### Water leakage through gap between lid and hopper.

#### DESCRIPTION:

Photo1. Hopper deformation.

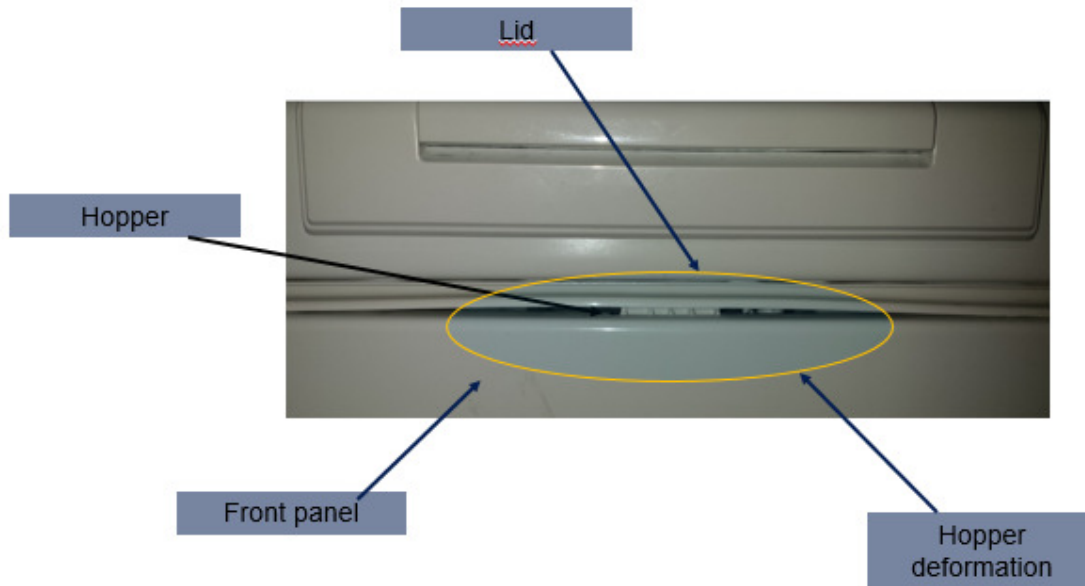
In some appliances, hopper deforms in door lock area. It causes water leakage through gap between lid and hopper.

Replace lid gasket and hopper. Components are available in kit 4055367710.
